SUNDRY NOTICES AND REPORTS ON WELLS

8. Well Name and No.
Lonesome Dove 25 Fed Com 1

9. API Well No.
30-015-31698

Rubicon proposes to plug back existing well to recomplate to the Grayburg from 2680 to 2700' utilizing a single stage fracture treatment via the 5 1/2" casing
Desired start date: 6/1/15

Lonesome Dove 25 Fed 1
Eddy County, New Mexico
Yeso Recomplete Wellbore
30-015-31698

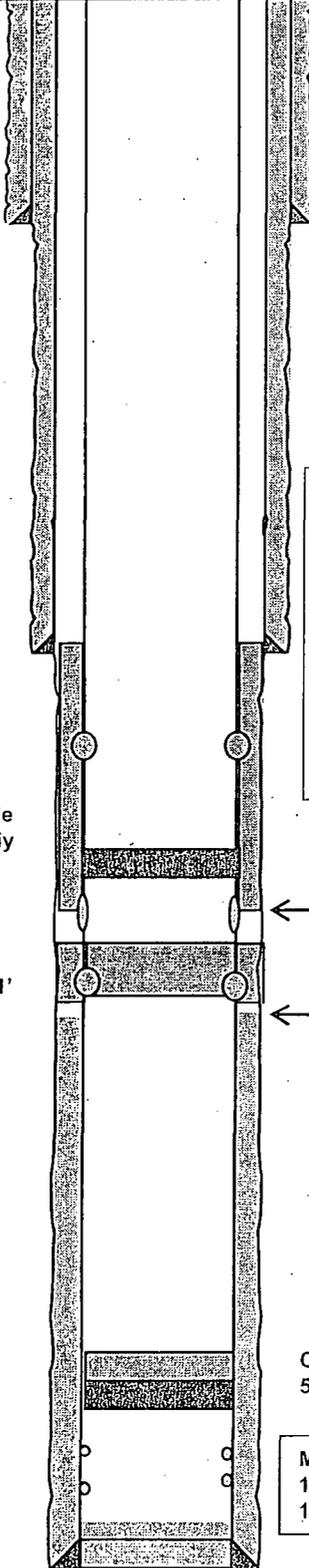
Well must be properly plug: Plugging requires a top of Glorietta plug at 4120 set a balance plug inside the 5-1/2" Also requires a shoe plug across 8-5/8" shoe inside 5-1/2: and in the 5-1/2" by 8-5/8" annulus. TOC at approx... 3160 per CBL dated 04-07-2014.

6. **Step #1 of Operator procedure Set CIBP at 4020'**
7. **Step #2 – OK this will also cover the top of Glorietta.**
8. **Step #3 and #4 –OK**
9. **Step #5 – Circulation of cement in the annulus to surface –OK. Operator also requires to have a balance plug within the 5-1/2" casing from 3150 to 3000'. The BLM shall be given the proper notice to witness setting plug and tagging of plug.**
